Addendum 50 – UN Regulation No. 51

Revision 3 - Amendment 6

Supplement 6 to the 03 series of amendments – Date of entry into force: 25 September 2020

Uniform provisions concerning the approval of motor vehicles having at least four wheels with regard to their sound emissions

"Figure 3a

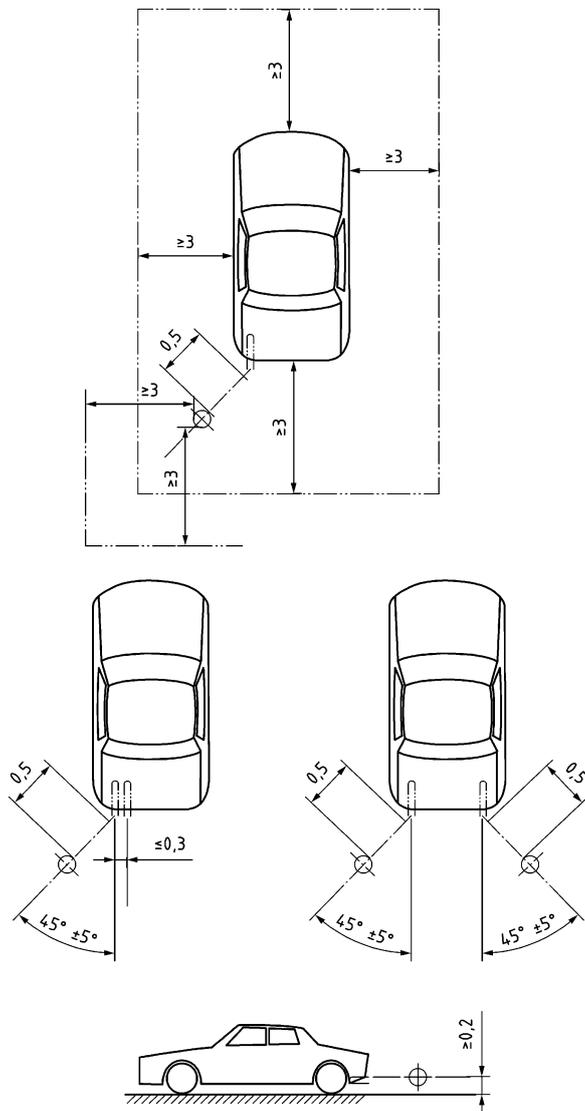
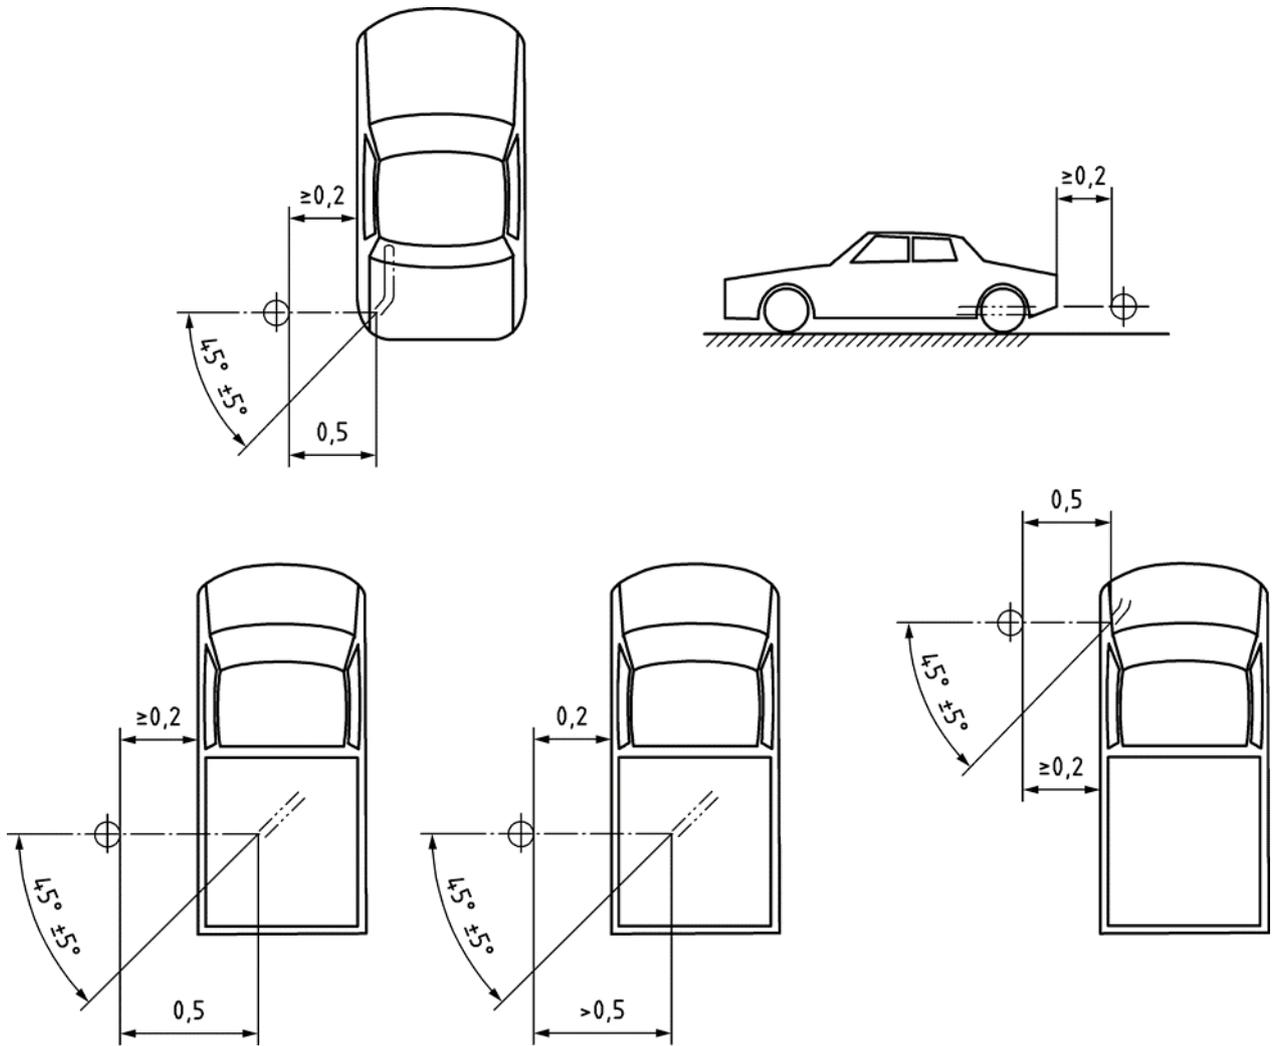
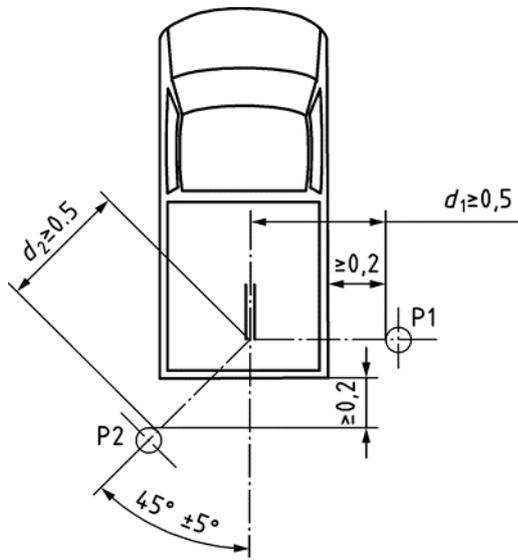
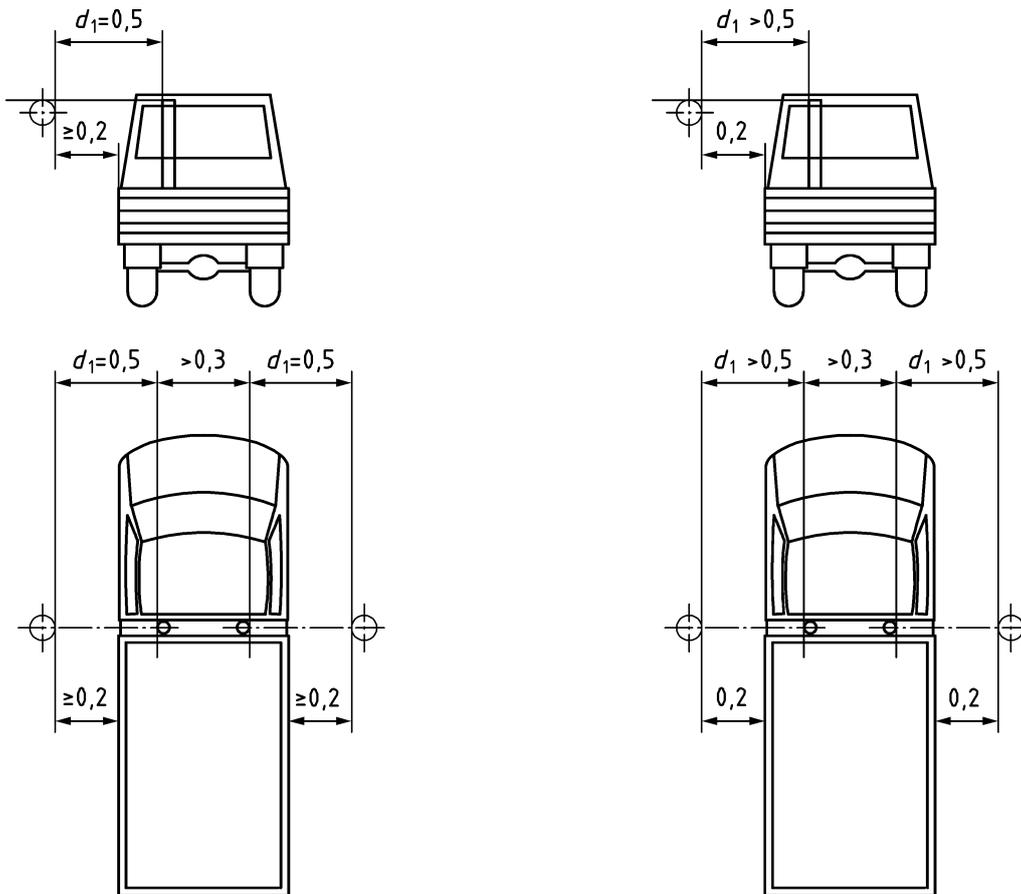
"3.2.5.3. Measuring of noise in proximity to the exhaust (see appendix of Annex 3, Figure 3a)."

"3.2.5.3.1.5. For vehicles, where the reference point of the exhaust pipe is not accessible, or located under the vehicle body, as shown in Figure 3b and 3c in Annex 3, because of the presence of obstacles which form part of the vehicle (e.g. spare wheel, fuel tank, battery compartment), the microphone shall be located at least 0.2 m from the nearest obstacle, including the vehicle body, and shall not be located under the vehicle. Its axis of maximum sensitivity shall face the exhaust outlet from the position least concealed by the above-mentioned obstacles. In case the distance from the exhaust outlet to the other side of the vehicle is larger than 0.2 m (Figures 3c and 3d in Annex 3), the following distances of d_1 and d_2 shall be chosen:

Annex 3

Appendix, amend to read:

Flowchart for vehicles tested according to paragraph 3.1.2.1. of Annex 3 to this Regulation
– L_{urban} computation

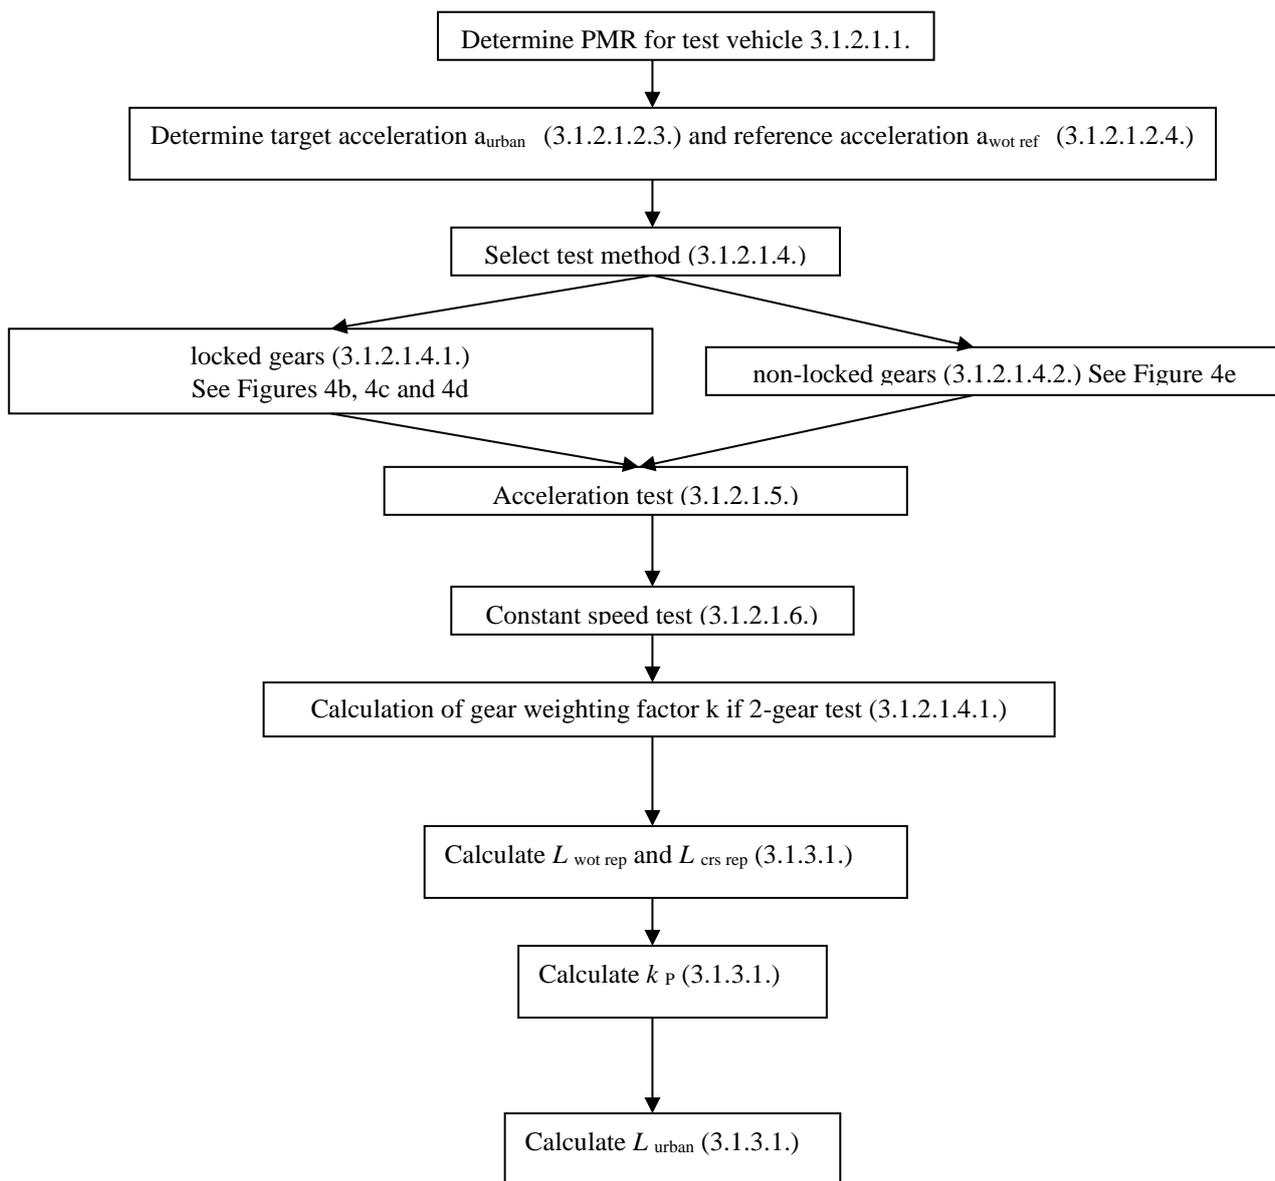
Figure 4a, amend to read:

Flowchart for vehicles tested according to paragraph 3.1.2.1. of Annex 3 to this Regulation
 - Gear selection using locked gear.

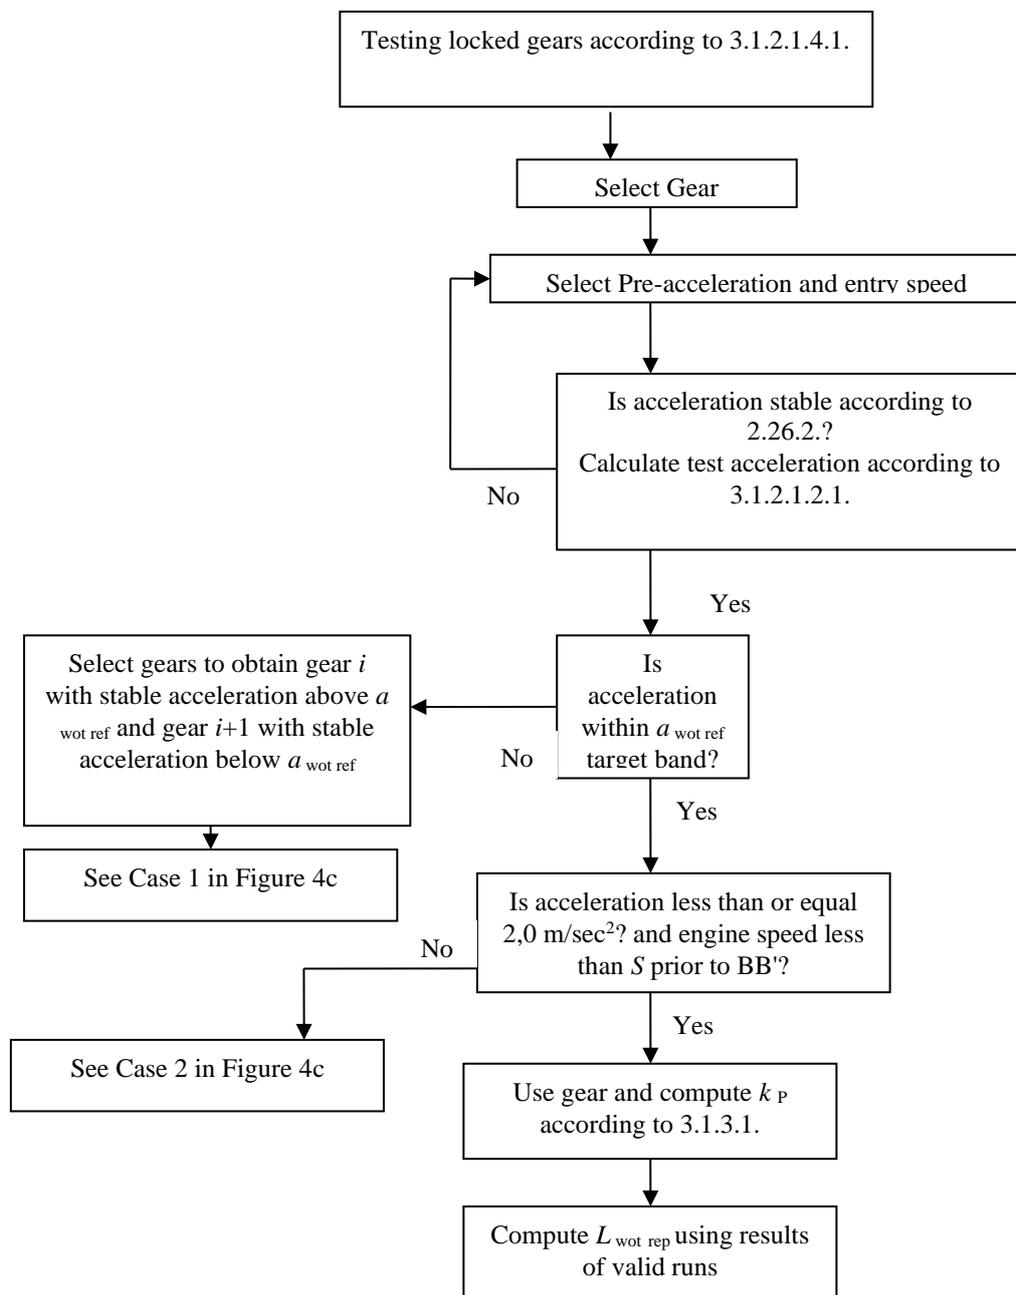
Figure 4b, amend to read:

"Figure 6
Flowchart for measurement and data processing of stationary sound according to paragraph 3.2.

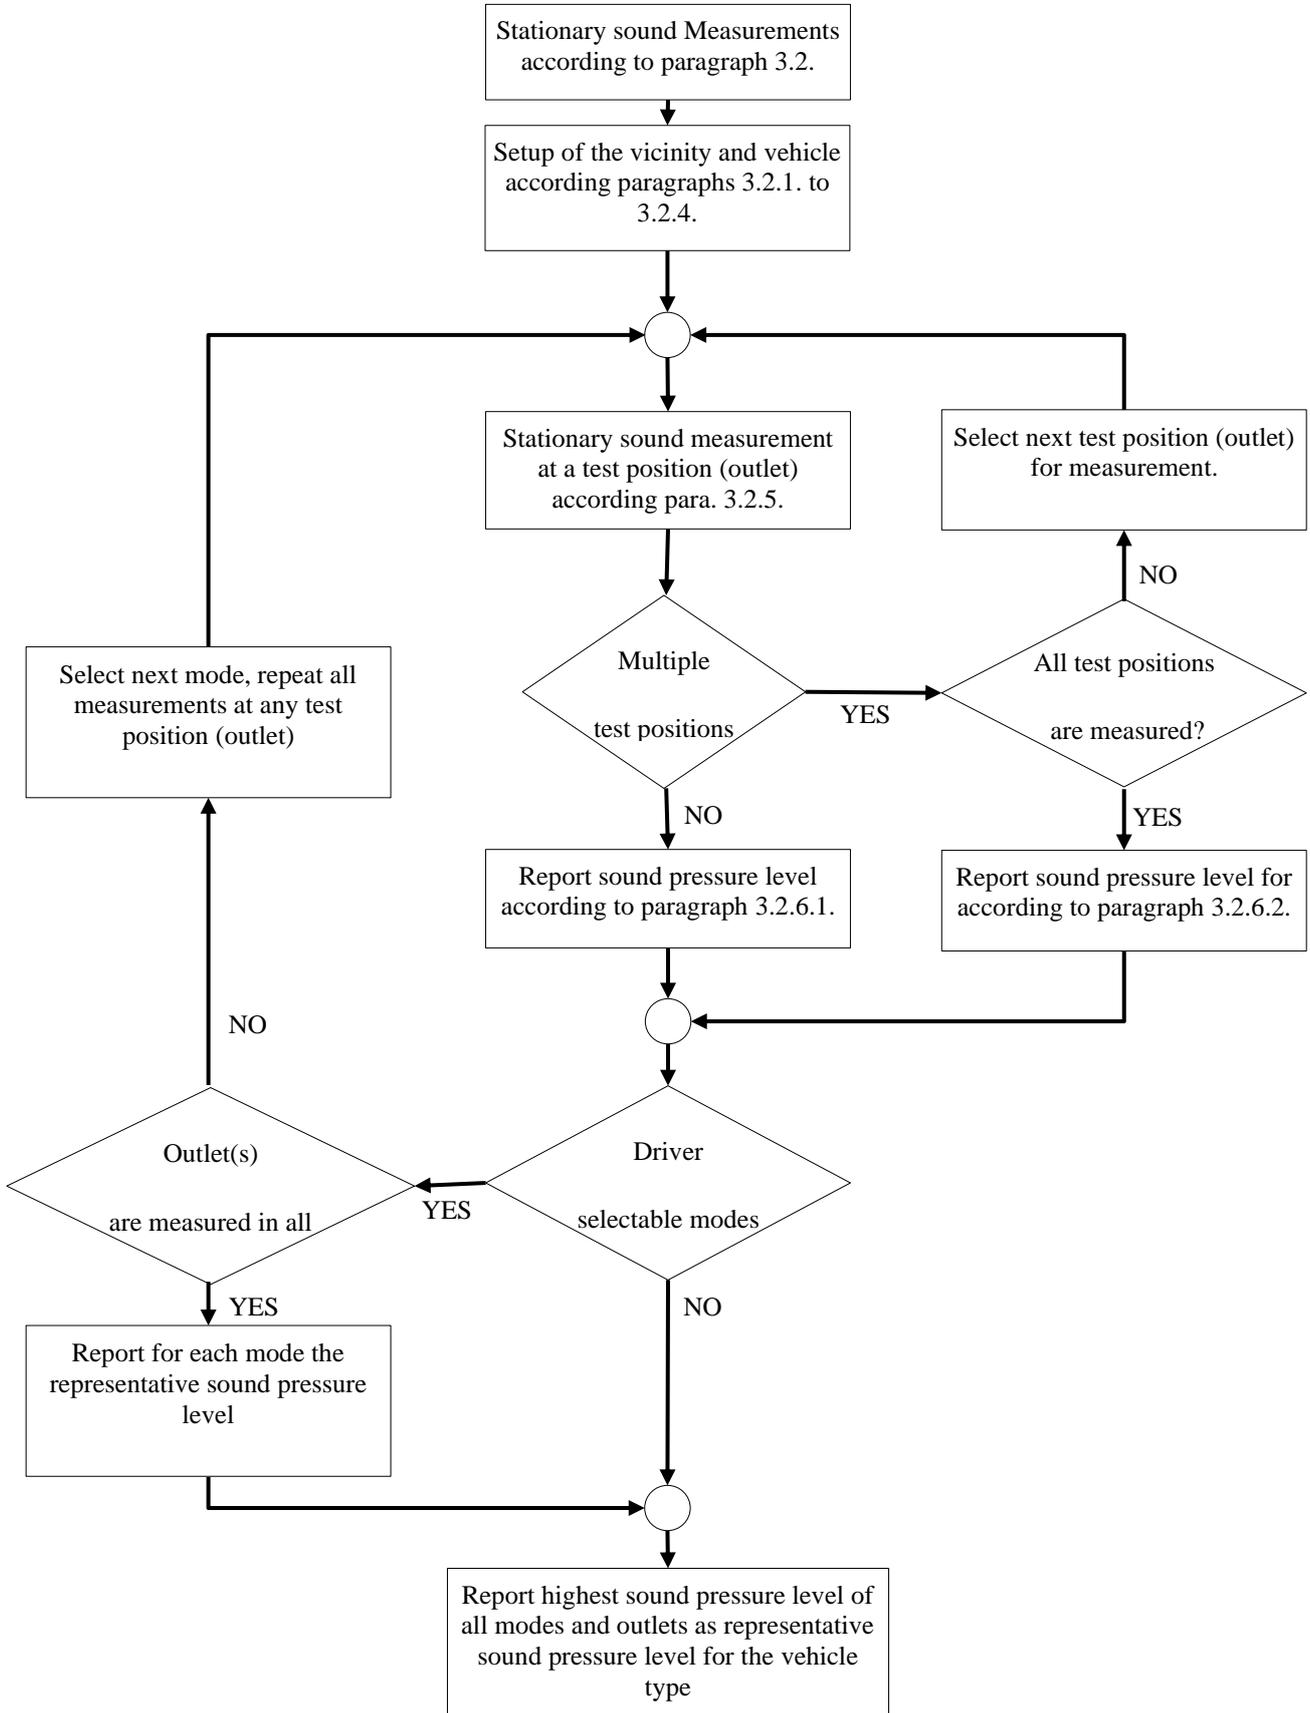
Add a new Figure 6:
